Liberty Utilities/iNATGAS Special Contract and Lease Agreement

Staff Data Requests – Set 4, Part 2

Date Request Received: 5/30/14  
Request No. Staff 4-3

A1 SITE PLAN  
SCALE: 1" = 60'

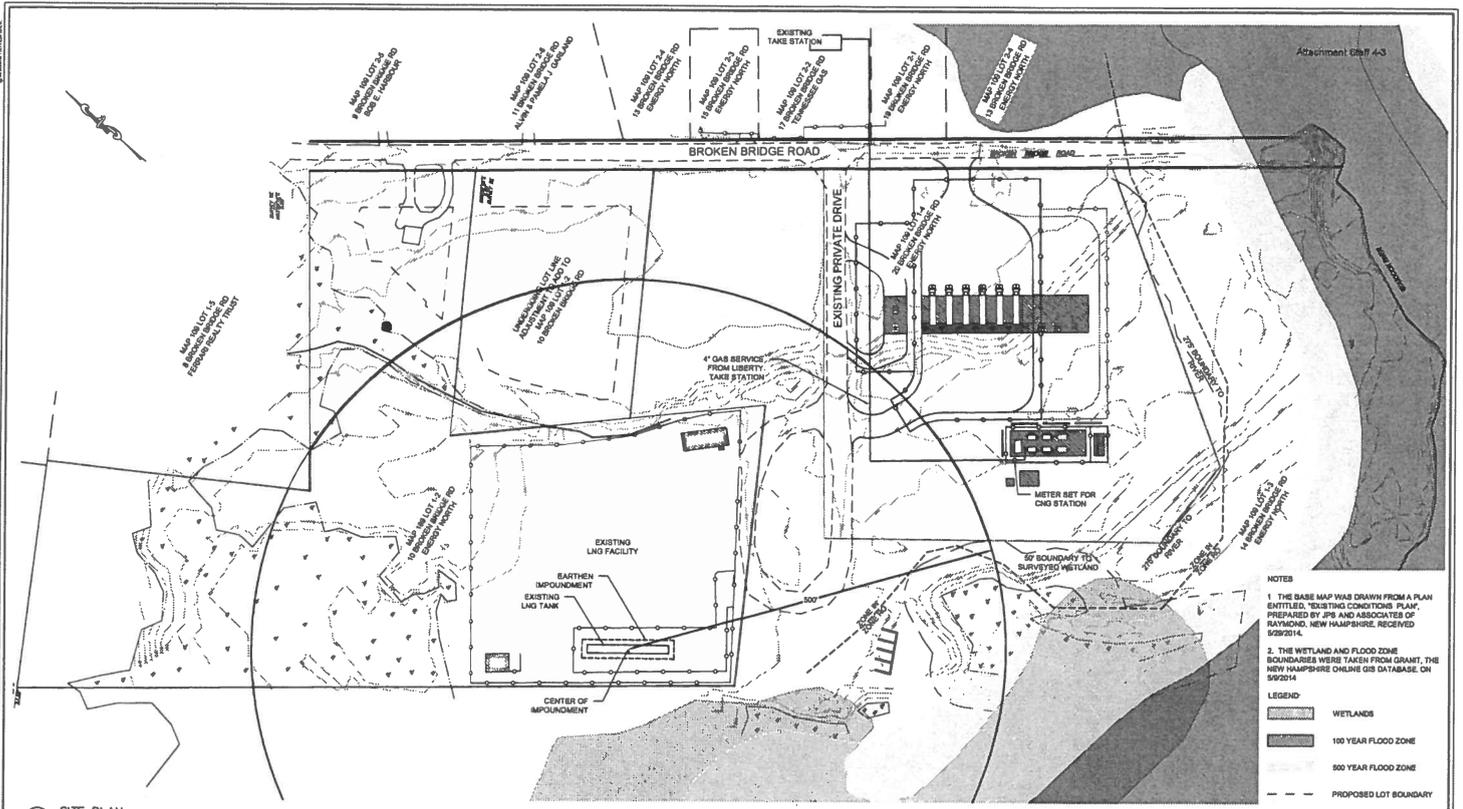
Re. the response to Attachment Staff 3-2, pages 1 through 4. Please provide revised copies of the site and equipment plan drawings that show the boundaries for the vapor dispersion zone and the thermal radiation zone of the existing LNG facility in relation to the proposed CNG facility.

Please see Attachment Staff 4-3 which includes boundaries for the vapor dispersion zone of the existing LNG facility in relation to the proposed CNG facility.
